Addendum No. 2
October 1, 2021

Project: **Harrisburg Middle School No. 3**
Harrisburg, South Dakota
Architecture Incorporated Project #2903

Architect: Architecture Incorporated

SD24

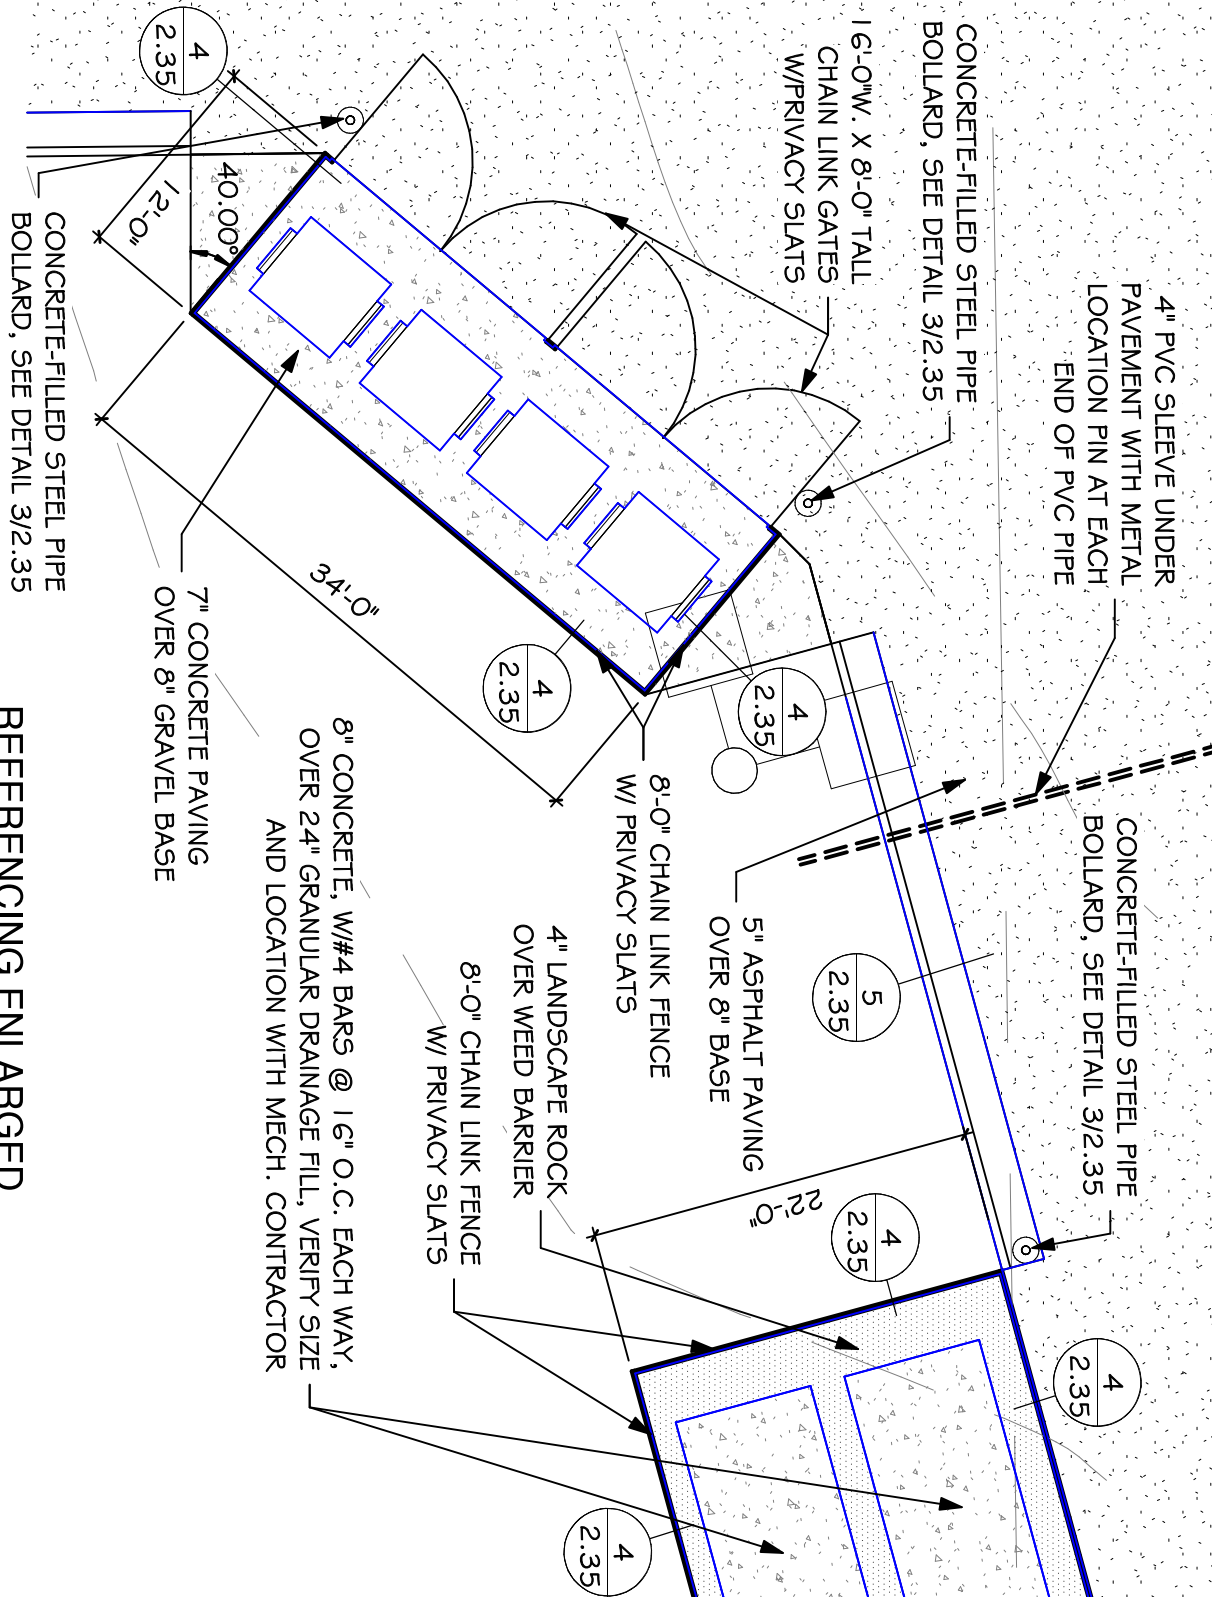
- d) Reference supplemental drawing SD24, dated 10-1-21, attached to the end of Addendum #2 for section of full height cmu wall for plumbing in Kitchen B154.

SD-25

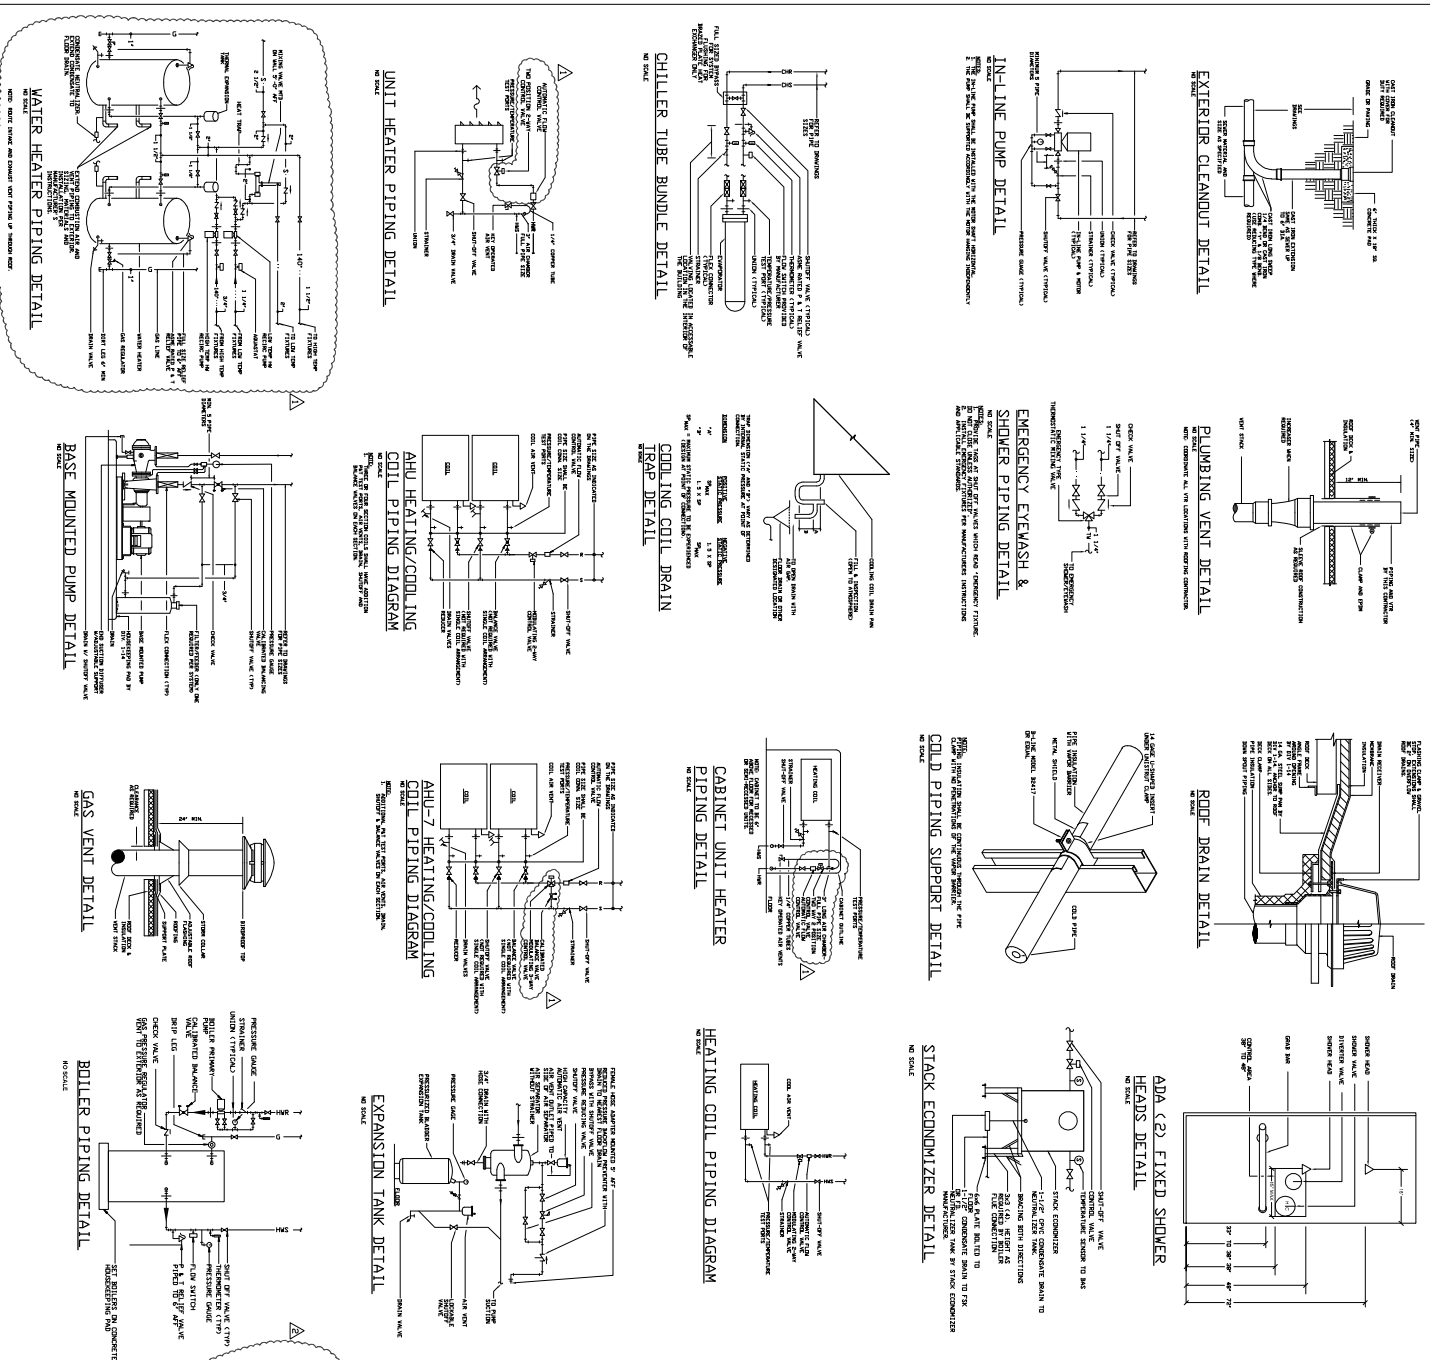
- a) Omit the 4" PVC lawn irrigation sleeve that serves the parking lot island in the staff parking lot.
- b) Modify the location / orientation of the dumpster enclosure as indicated per supplemental drawing SD25, dated 10-1-21, which is attached to Addendum #2.
- c) The 4" *LANDSCAPE ROCK OVER WEED BARRIER* shown in the parking lot islands shall be furnished and installed by the Owner.
- d) Asphalt paving: Change the heavy-duty asphalt paving to 5" of asphalt over 4" of base; change the light-duty asphalt paving to 4" of asphalt over 4" of base; as noted on Sheet 2.40.
